823 Congress 57.

LAND USE - ZONING REPORT

BUILDING PERMIT REPORT
DATE: 9 July 2000 ADDRESS: 823 Congress ST. CBL: 053- C- 032
PATE: 9 July: 2000 ADDRESS: 823 Congross ST. CBL: 053-C-032 REASON FOR PERMIT: Renova Trons of Phatforms, Starrs & railings
BUILDING OWNER: POST Re Source S
PERMIT APPLICANT: /CONTRACTOR EasTern Shores Home Inpro
USE GROUP: B-2 CONSTRUCTION TYPE: 5 B CONSTRUCTION COST! 5/566 PERMIT FEES: 32466
The City's Adopted Building Code (The BOCA National Building code/1999 with City Amendments) The City's Adopted Mechanical Code (The BOCA National Mechanical Code/1993)
CONDITION(S) OF APPROVAL
This permit is being issued with the understanding that the following conditions are met: */ *// */3 *29 *32
 This permit does not excuse the applicant from meeting applicable State and Federal rules and laws. Before concrete for foundation is placed, approvals from the Development Review Coordinator and Inspection Services must be obtained. (A 24 hour notice is required prior to inspection) "ALL LOT LINES SHALL BE CLEARLY MARKED BEFORE CALLING."

11:11 DD 11:11 mm 1 - 2 × 4 823 Congress ST. 42½" - 2×2 BALASTER 724 274 11" Rise - 14'11" Ø Replacement Stairs
existing footprint 1 ALL 8 1/6" Fi SE ALL 10% TREAD 734 RisE 331/2" 42 RAIL HEIGHT SIDEWALK

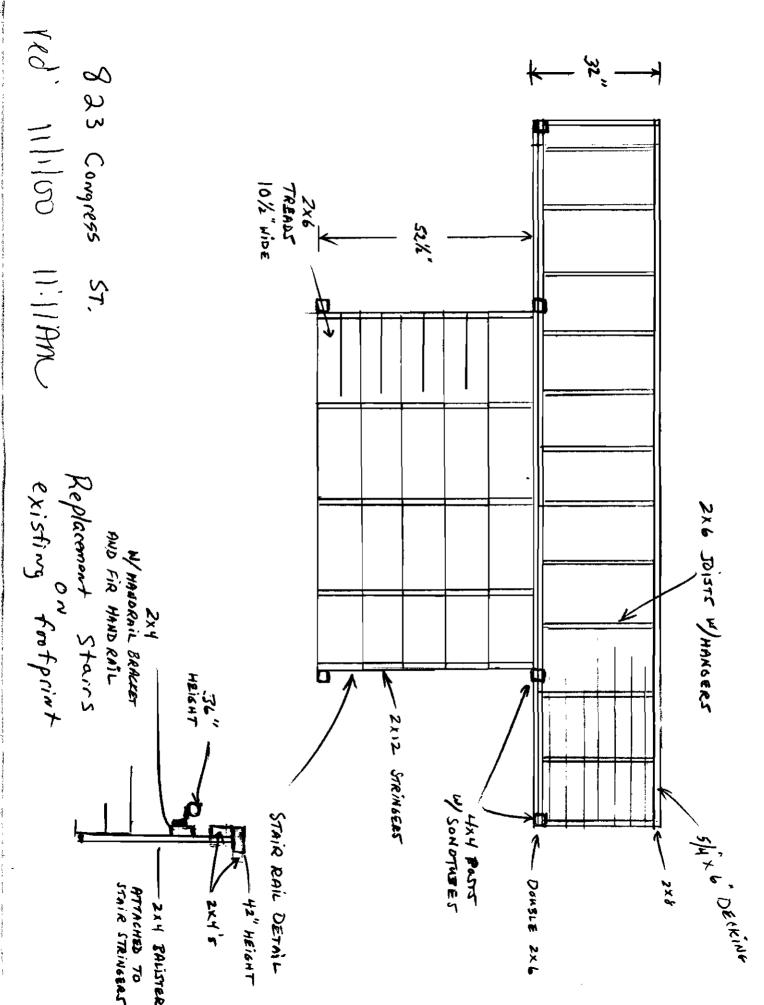
10. Sound transmission control in residential building shall be done in accordance with Chapter 12, Section 1214.0 of the City's Building Code. 11. Guardrails & Handrails: A guardrail system is a system of building components located near the open sides of elevated walking surfaces for the purpose of minimizing the possibility of an accidental fall from the walking surface to the lower level. Minimum height all Use Groups 42". In occupancies in Use Group A,B.H-4, I-1, I-2, M and R and public garages and open parking structures, open guards shall have balusters or be of solid material such that a sphere with a diameter of 4" cannot pass through any opening. Guards shall not have an ornamental pattern that would provide a ladder effect. (Handrails shall be a minimum of 34" but not more than 38". Exception: Handrails that form part of a guard shall have a height not less than than 36" and not more than 42". Handrail grip size shall have a circular cross section with an outside diameter of at least 1

13. Stair construction in Use Group R-3 & R-4 Is a minimum of 10" tread and 7 %" maximum rise. All other Use Group minimum 11" tread,

"and not greater than 2". (Sections 1021 & 1022.0). Handrails shall be on both sides of stairway. (Section 1014.7)

7" maximum rise. (Section 1014.0)

19. All single and multiple station smoke detectors shall be of an approved type and shall be installed in accordance with the provisions of the City's Building Code Chapter 9, Section 920.3.2 (BOCA National Building Code/1999), and NFPA 101 Chapter 18 & 19. (Smoke detectors shall be installed and maintained at the following locations): In the immediate vicinity of bedrooms In all bedrooms 🦠 In each story within a dwelling unit, including basements 20. A portable fire extinguisher shall be located as per NFPA #10. They shall bear the label of an approved agency and be of an approved type. (Section 921.0) 21. The Fire Alarm System shall be installed and maintained to NFPA #72 Standard. 22. The Sprinkler System shall be installed and maintained to NFPA #13 Standard. 23. All exit signs, lights and means of egress lighting shall be done in accordance with Chapter 10 Section & Subsections 1023.0 & 1024.0 of the City's Building Code. (The BOCA National Building Code/1999) 24. Section 25 - 135 of the Municipal Code for the City of Portland states, "No person or utility shall be granted a permit to excavate or open any street or sidewalk from the time of November 15 of each year to April 15 of the following year". 25. The builder of a facility to which Section 4594-C of the Maine State Human Rights Act Title 5 MRSA refers, shall obtain a certification from a design professional that the plans commencing construction of the facility, the builder shall submit the certification the Division of Inspection Services. 26. Ventilation and access shall meet the requirements of Chapter 12 Sections 1210.0 and 1211.0 of the City's Building Code. (Crawl spaces & attics). 27. All electrical, plumbing and HVAC permits must be obtained by a Master Licensed holders of their trade. No closing in of walls until all electrical (min. 72 hours notice) and plumbing inspectious have been done. 28. All requirements must be met before a final Certificate of Occupancy is issued. ₹-29. All building elements shall meet the fastening schedule as per Table 2305.2 of the City's Building Code (The BOCA National Building Code/1996). 30. Ventilation of spaces within a building shall be done in accordance with the City's Mechanical code (The BOCA National Mechanical Code/1993). (Chapter M-16) Please read and implement the attached Land Use Zoning report requirements. See AT 31. Boring, cutting and notching shall be done in accordance with Sections 2305.3, 2305.3.1, 2305.4.4 and 2305.5.1 of the City's Building Code. 33. Bridging shall comply with Section 2305.16. 34. Glass and glazing shall meet the requirements of Chapter 24 of the building code. (Safety Glazing Section 2406.0) 35. All signage, shall be done in accordance with Section 3102.0 signs of the City's Building Code, (The BOCA National Building Code/1999). 10" Sogo Tubo shall be a minimum of 4" Bachorage Shall be provided between and Cahumniand deck Framing
